SUBJECT: First Baptist Church, Canco Road and Washington Avenue

FIRST BAPTIST CHURCH BALCONY AND PARKING ADDITION
SITE PLAN, CONDITIONAL USE REVIEW
FIRST BAPTIST CHURCH, APPLICANT

SUBJECT: First Baptist Church Balcony and Parking

Re: First Baptist Church Revisions

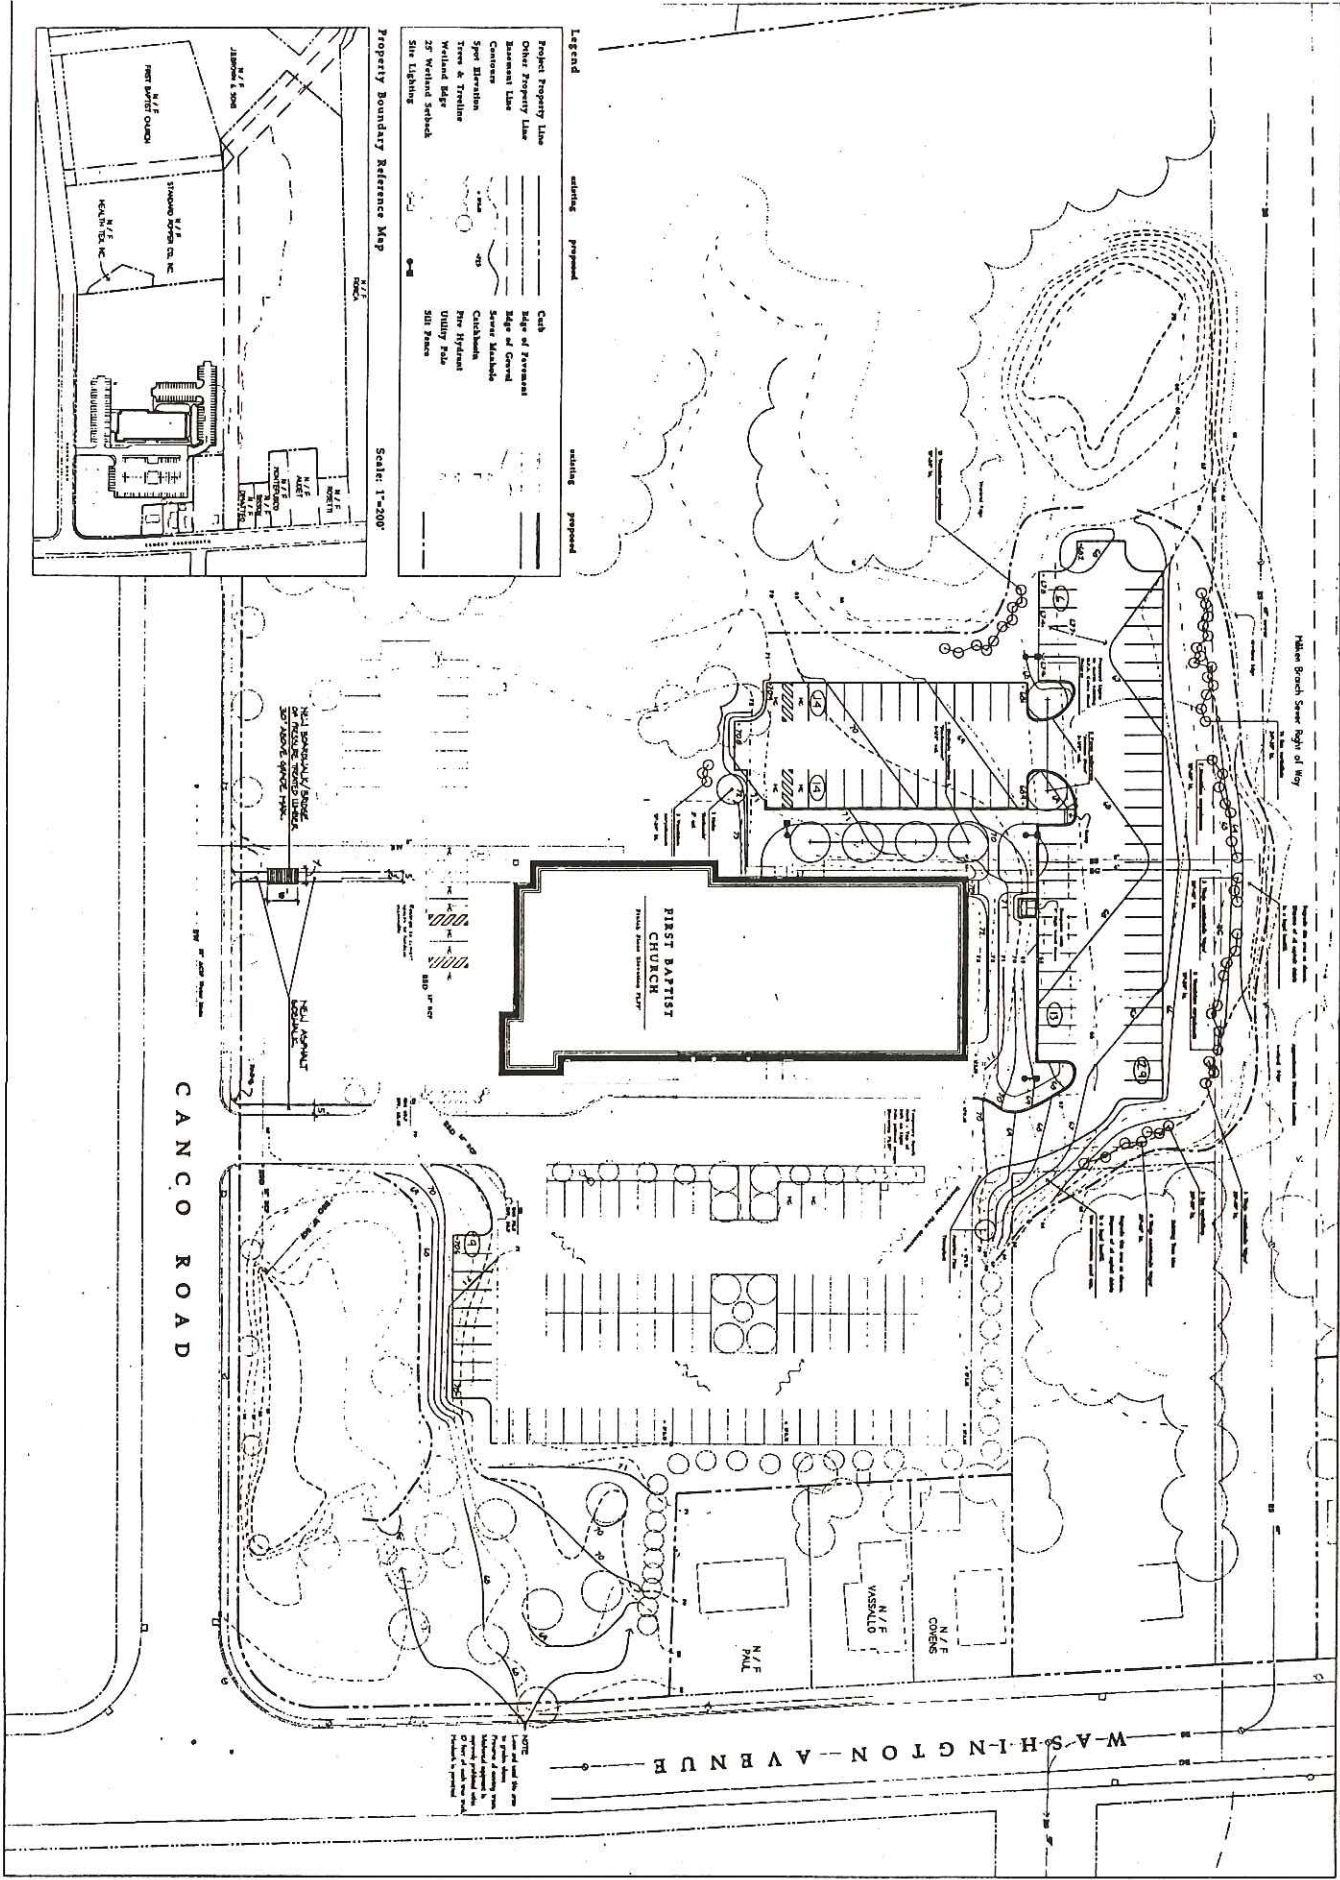
Revisions to site plan:
 1) addition of 5 deciduous trees and 3 evergreen trees
 2) addition of 2 site lights (4 total)

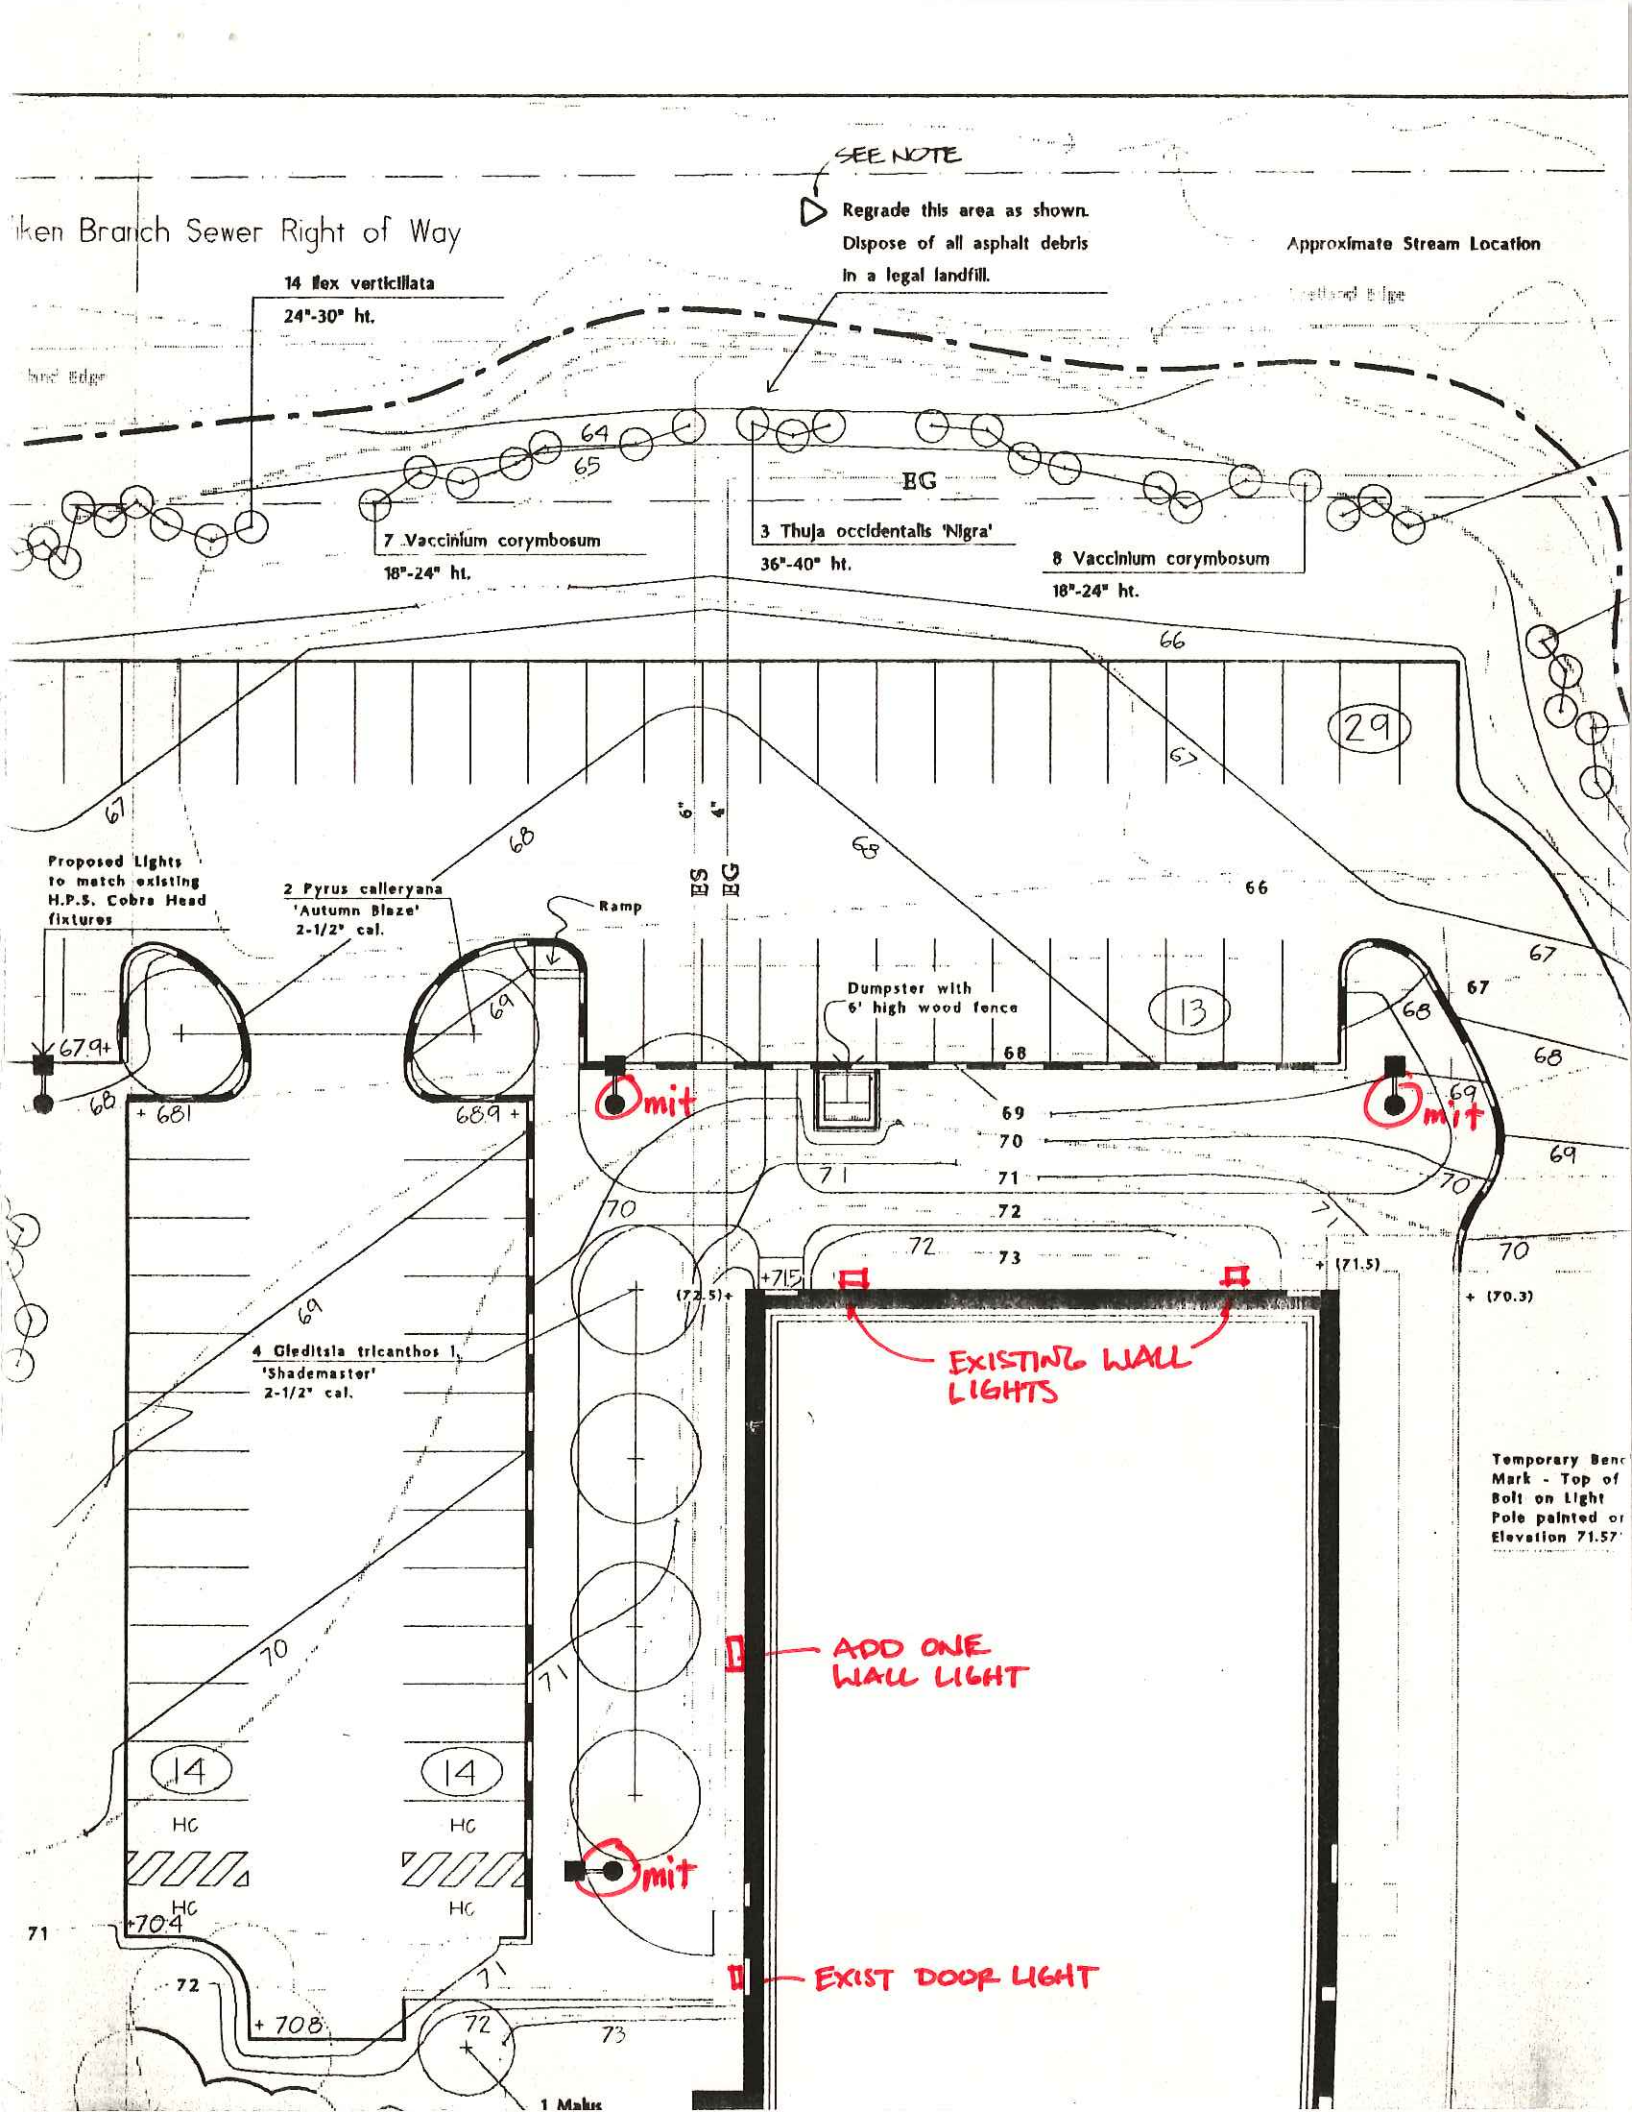
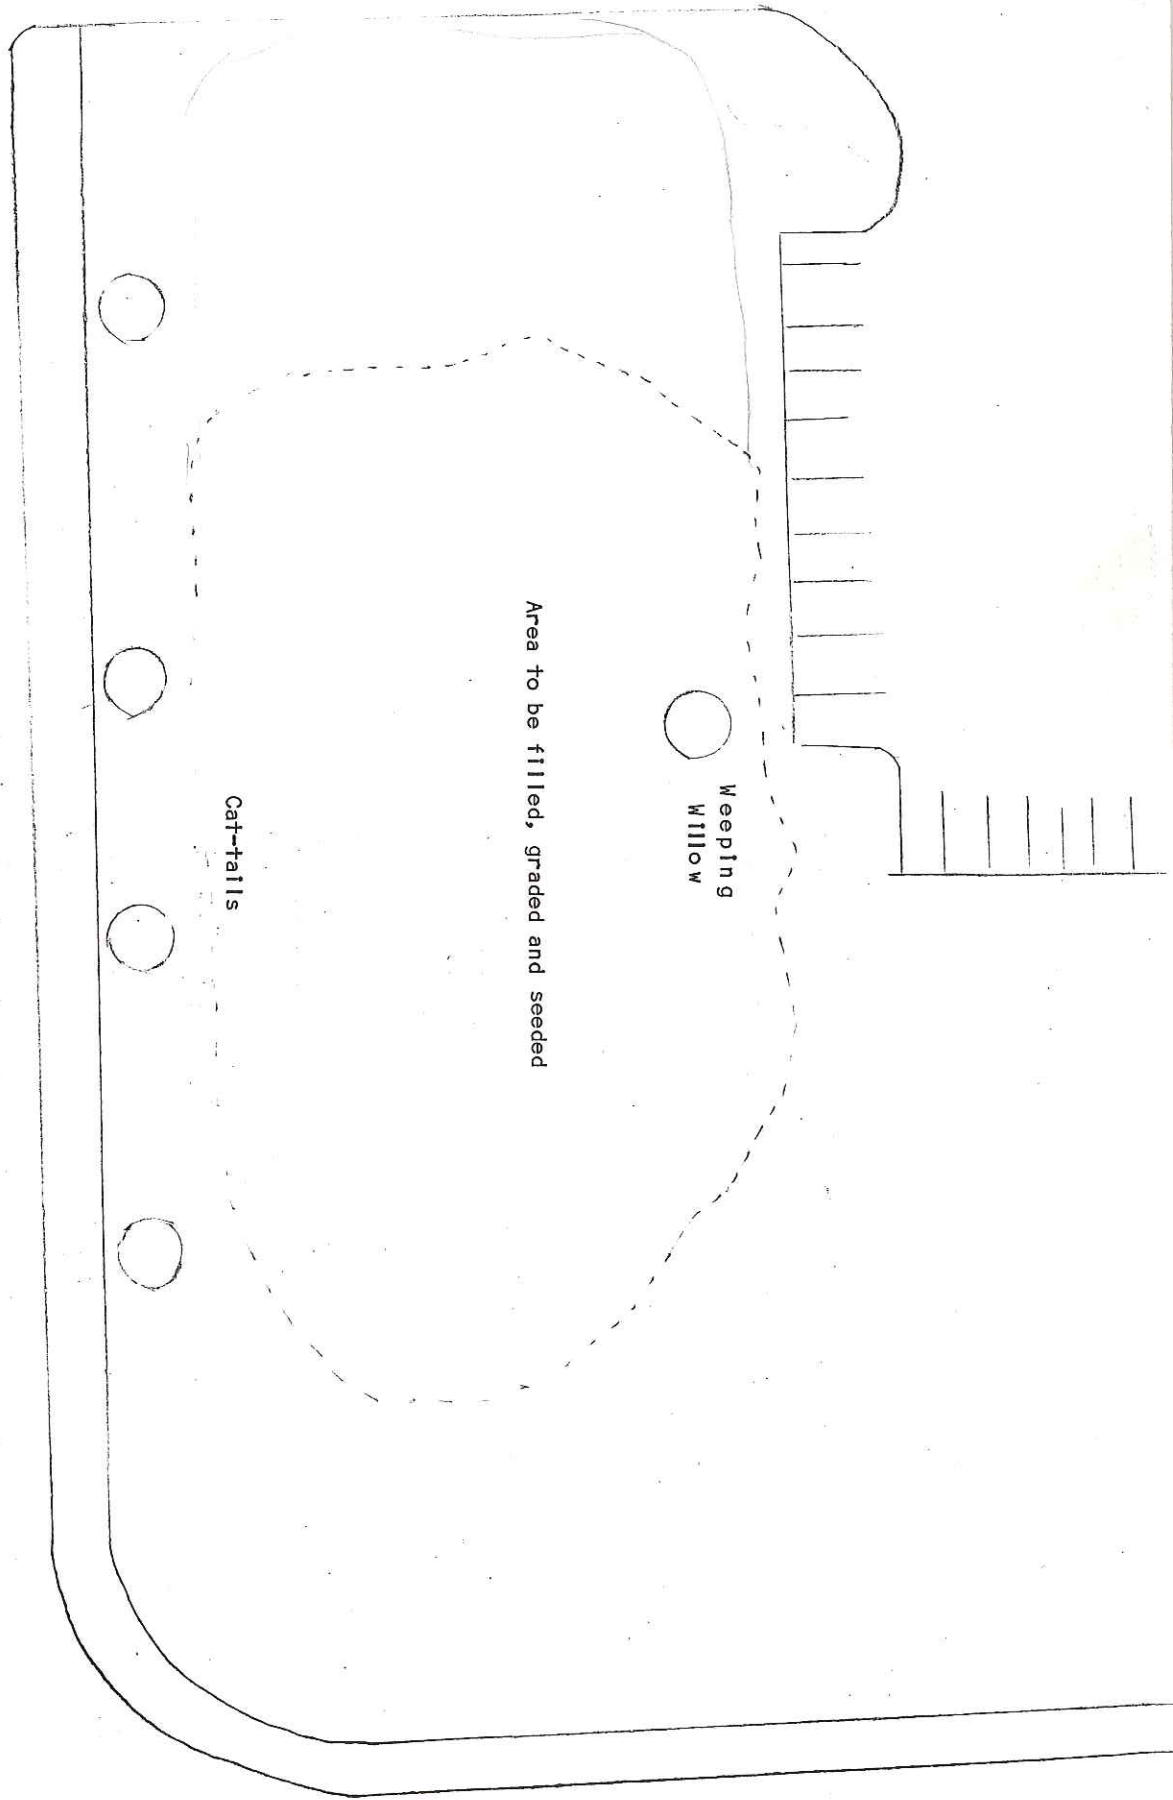
1. The regrading and reseeding of the section of land next to Washington Ave. will not be done at this time.
2. Three pole lights will be omitted and the lighting accomplished by two existing wall lights and the addition of one wall light. The fourth pole light furthest away from the building will remain.

FORGO THIS WORK

Regrade this area as shown.
Dispose of all asphalt debris
in a legal landfill.

This letter is to confirm the revision to the approved site plan of the First Baptist Church project located at the intersection of Canco Road and Washington Avenue. The approved revision includes omission of the regrading and reseeding of the front lawn and changes to the lighting plan. The revised plan has been reviewed and approved by the project review staff including representatives of the Planning, Public Works, Building Inspections, Fire and Parks Departments.
